Staff Report to the Advisory Design Panel

SUBJECT: 19072 Advent Rd

FILE: 3060-20-2022-01

RECOMMENDATION(S): THAT the Advisory Design Panel:

Figure 1: Site Plan

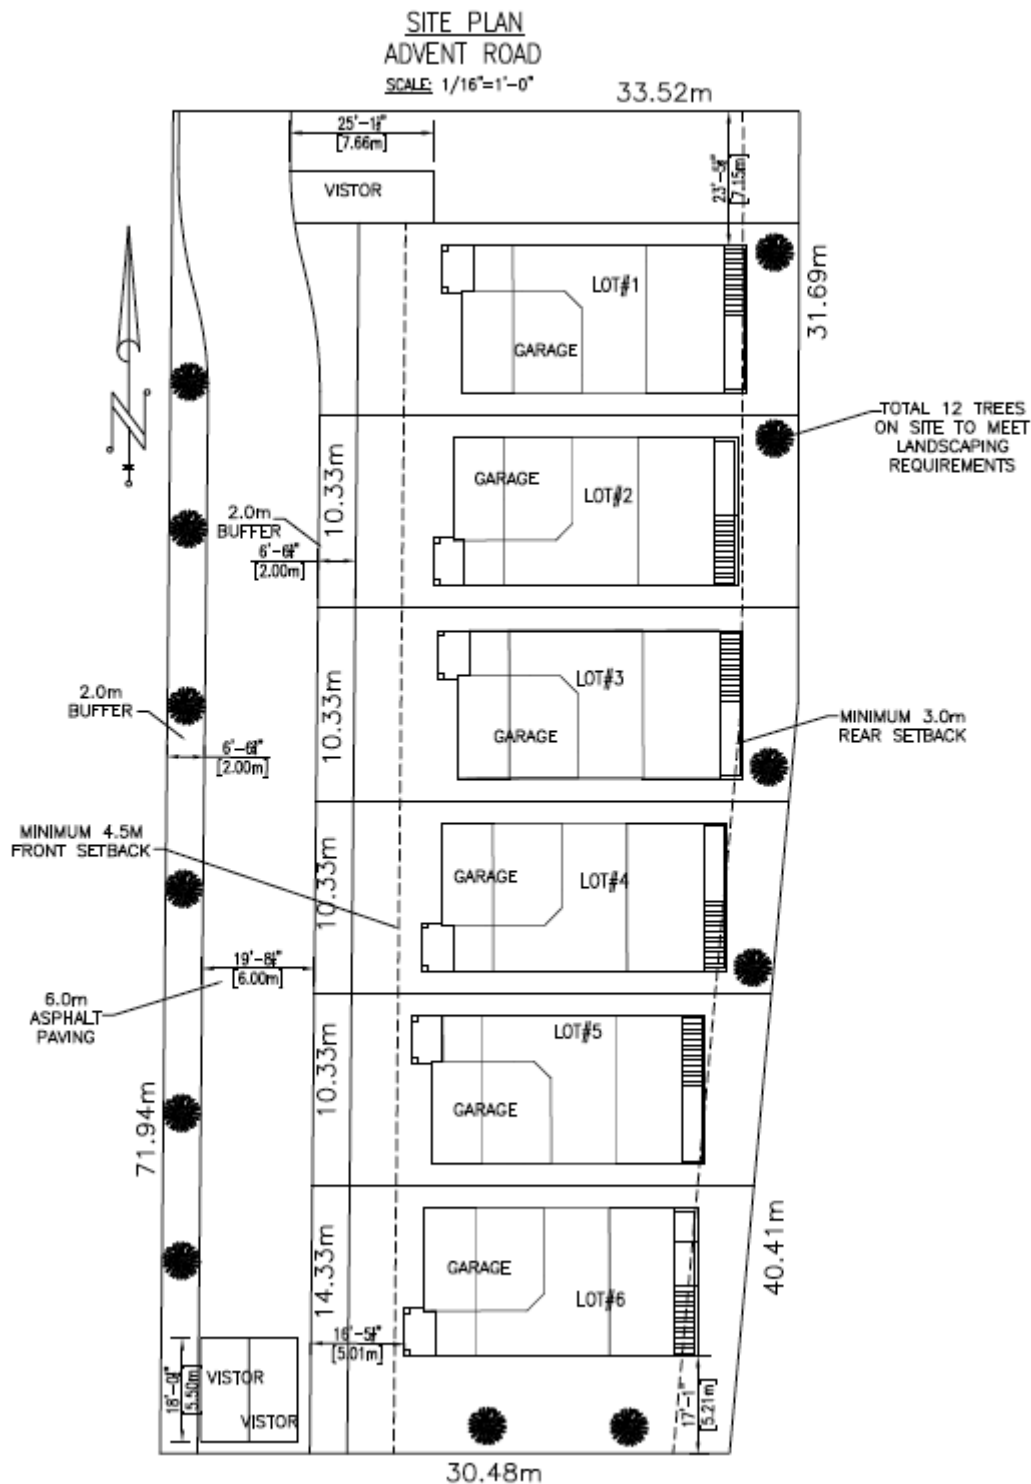
This development is different from a typical single family detached development in that the homes are oriented towards the internal drive aisle, rather than a City street. Given its bare land strata nature, this development is likely to feel and act as more of a traditional townhouse complex than a typical group of six new single-family dwellings. In general, the proposed homes comply with the guidelines found in DPA No. 11 for infill housing, however some of the guidelines are intended more for typical single-family lots and are not applicable to this proposal.

The front facades of the houses are broken up into smaller elements. The second levels are half-storeys and therefore stepped back, front porches are used to emphasize the main entrances, roofs are pitched, and multiple cladding materials are used. Permeable pavers are proposed for the visitor parking spaces to reduce the overall impervious surface area.

The guidelines suggest that garage doors be limited to not more than 50% of the width of the total building front. In this application, the homes are proposed as 26' wide with 16' garage doors, so this guideline is not complied with. The intent of this guideline is to minimize the visual impact of garages to the street. In this case, the garages face the internal drive aisle rather than the street, so strict compliance with this particular guideline is not essential. While a single car garage would satisfy this guideline, providing ample parking was a key concern shared by neighbouring residents and Council during the rezoning stage and, therefore, double garages are recommended. As a condition of rezoning, a covenant is being registered on title to restrict conversion of these double garages into living space in the future.
